Bulletin No. 2002-04

## Idle Relief Noise - 40 thru 60 Four Stroke

2002 40/50/60 (4 Cyl.) Four Stroke

**27-825251--3 Drive Shaft Housing to Adaptor Plate Gasket**

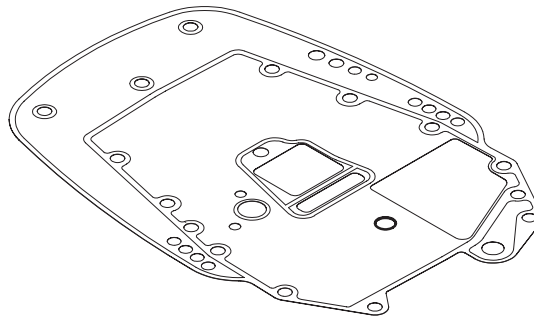
The adapter plate gasket (27-825251--3) that is installed between the adapter plate and the drive shaft housing on affected four-stroke outboards may create a vibration noise between 1500 and 3000 RPM. This noise is created by exhaust pressures in the adaptor plate idle system and causes the gasket to vibrate.

### Location of Additional Hole

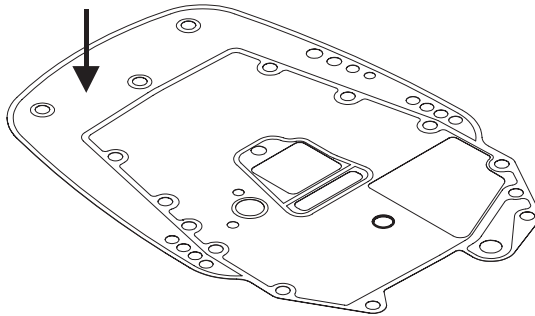
Replace the existing adapter plate to drive shaft housing gasket with a revised gasket 27-825251--6 or 27-825251--7 that has the additional hole. The additional hole is 11/32 inch (8.5 mm) diameter and located midway between the rear center and the rear starboard driveshaft housing bolt holes.

### Torque Sequence

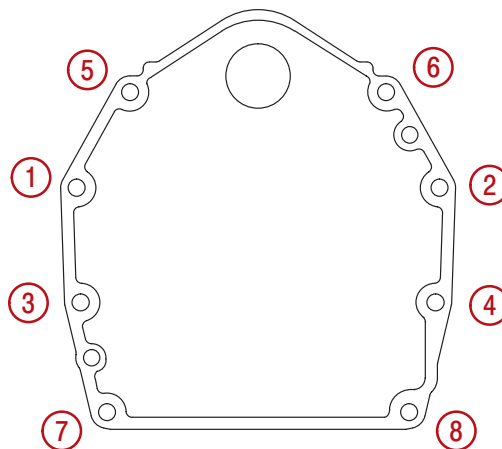
When reassembling, it is very, very important to torque the powerhead bolts to the proper torque and in the proper sequence.

▲ Torque 28 lb-ft. (38 Nm)
